ERRATA SHEET

PRODUCT FAMILY:	<i>GS2 AC Drives</i>	ERRATA SHEET NUMBER:	<i>GS2-M Errata #7</i>
USER MANUAL NUMBER:	<i>GS2-M</i>	ERRATA SHEET DATE:	<i>11/17/2020</i>
USER MANUAL REV & DATE:	<i>1st Ed, Rev C; 12/2006</i>

EXAMPLE 6: POSITIVE OFFSET WITH REDUCED ANALOG GAIN

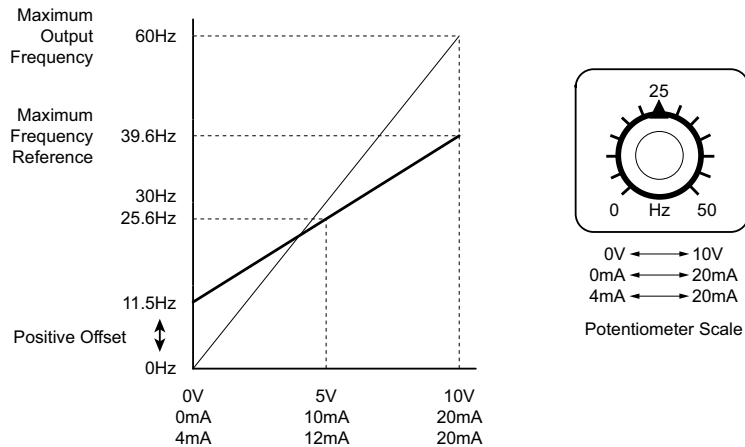
Add a new Analog Parameter Example #6 for positive offset with reduced gain as shown:

This example illustrates how to provide a positive offset of the Analog Input, while using the full scale of the potentiometer or other analog device. At the same time, the Maximum Frequency Reference is limited by reducing the Analog Input Gain. When the analog signal is at its lowest value, the set-point frequency will be at 11.5Hz. When the analog signal is at its maximum value, the set-point frequency will be 39.6Hz.

- A) Max output frequency = (1750rpm ÷ 1750rpm) x (60Hz) = 60Hz
- B) Analog Offset % = (11.5Hz ÷ 60Hz) x 100 = 19.2%
- C) Analog Gain % = ((39.6Hz - 11.5Hz) ÷ 60Hz) x 100 = 46.8%
- D) Mid-point frequency = ((39.6Hz - 11.5Hz) ÷ 2) + (11.5Hz) = 25.6Hz

- P4.01: 01 [Positive Input Offset Polarity]
- P4.02: 19.2 [19.2% Analog Input Offset]
- P4.03: 46.8 [46.8% Analog Input Gain]
- P4.04: 00 (default) [Forward Motion Only]

P6.00 Electronic Thermal Overload Relay

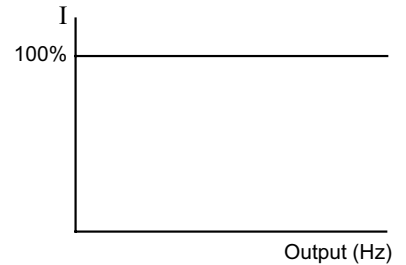
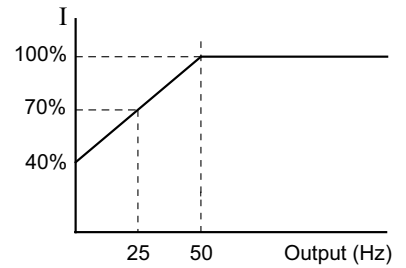
Revise P6.00 description as shown:

00 Constant Torque (Recommended **for inverter/vector duty motors**)

01 Variable Torque (Recommended **for fan-cooled standard motors**)

Use this setting when using the drives with motors which are NOT designed specifically for AC drive outputs. Motors with shaft mounted fans offer poor cooling at low speeds; therefore the output can be derated at lower output frequencies. This derated current is for protecting the motor at lower speeds.

$$I_{\text{output}} (\%) = [f_{\text{output}} (\text{Hz}) \times 1.2 (\% / \text{Hz})] + 40\%$$

DL250(-1): RS-485 Connection Wiring

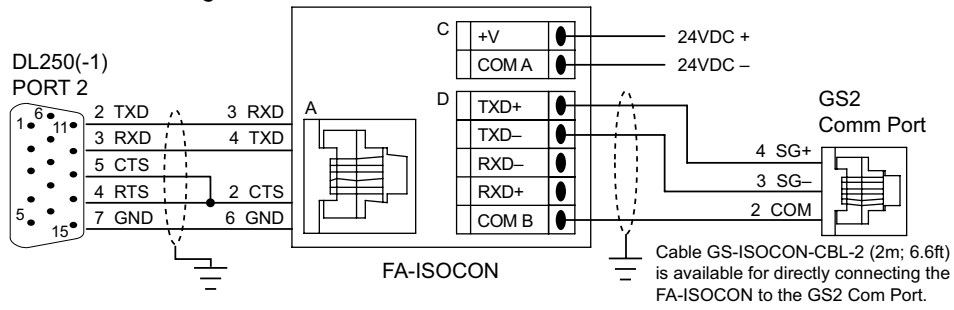
Revise DL250 RS-485 wiring diagram (pg.5-13) as shown:

DL06/DL260/D0-DCM: RS-485 Connection Wiring – for distances of 2 meters (6.6 ft) or less

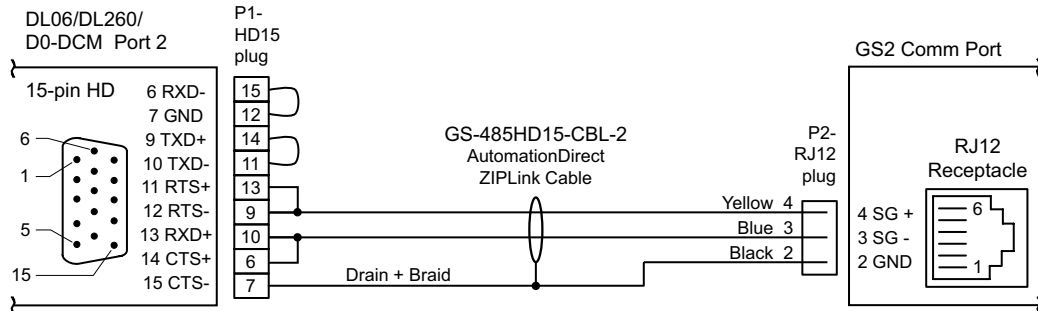
Add/Revise DL06/DL260/D0-DCM RS-485 wiring diagrams (pg.5-14) as shown:

GS SERIES-SPECIFIC PART NUMBER EXPLANATION

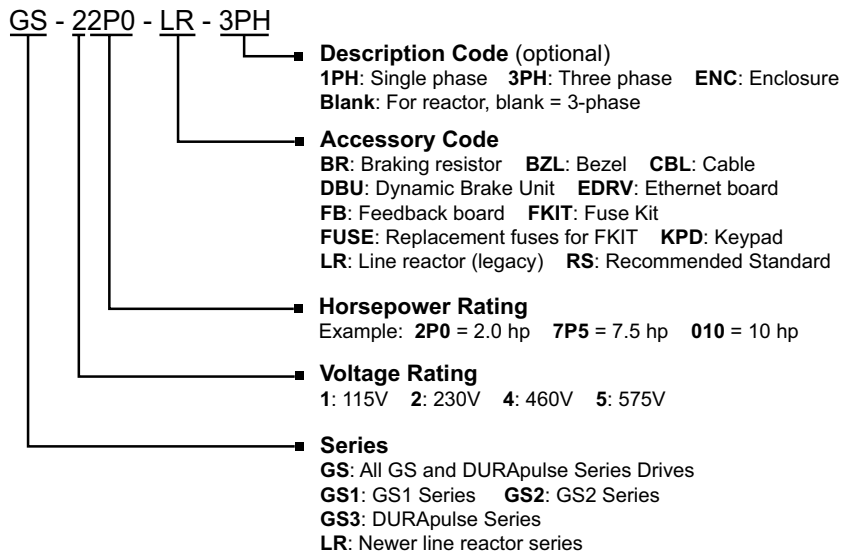
Replace “Accessories Part Numbering” and “Line Reactors” information as shown:

With the exception of EMI filters, RF filters, and LR(2) series line reactors, each accessory part number begins with GS, followed by the AC Drive rating, and then the relevant accessory code. Following the accessory code, you will find a description code when applicable. The diagram below shows the accessory part numbering scheme.

FUSE BLOCK SINGLE-PHASE 115VAC WIRING

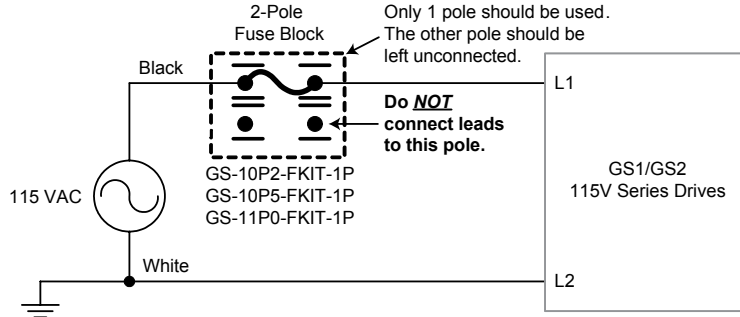
Add fuse block single-phase 115VAC wiring information and warning as shown:

WARNING: THE SINGLE-PHASE FUSE KITS CONTAIN A 2-POLE FUSEBLOCK. PER NEC 240.22, FUSING IS CORRECT ONLY FOR THE HOT LEG OF A SOURCE; NOT FOR AN INTENTIONALLY GROUNDED SOURCE CONDUCTOR. THE HOT LEG OF A GROUNDED 115VAC SUPPLY IS THE ONLY SUPPLY LINE THAT SHOULD BE FUSED.
